IN THE DRAWINGS:

REMARKS

FIG. 1

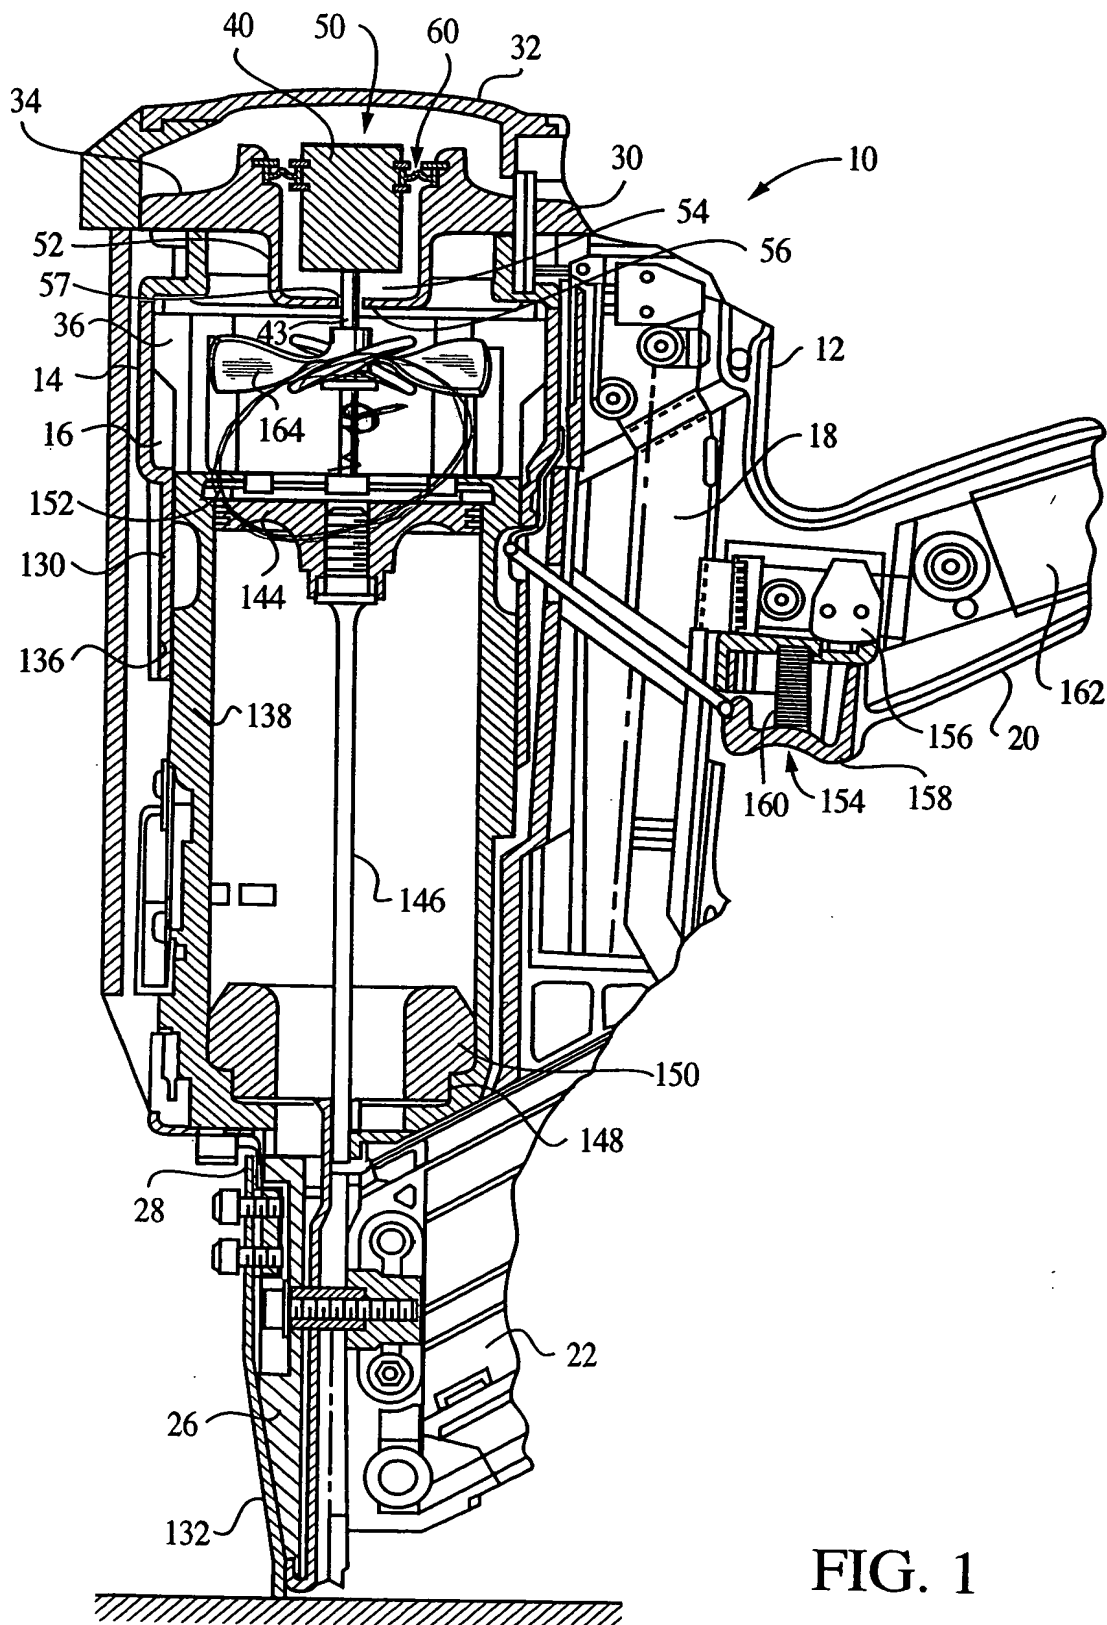
Please approve the drawing change as shown in red on the attached marked-up copy of Fig. 1. A separate Letter to the Draftsman indicating the same proposed drawing change is also enclosed.

FIG. 1 has been amended to remove a portion of armature shaft 43. Applicant respectfully submits that no new matter is presented by this amendment, as the correct configuration of the armature shaft is clearly shown, for example, in FIG. 2.
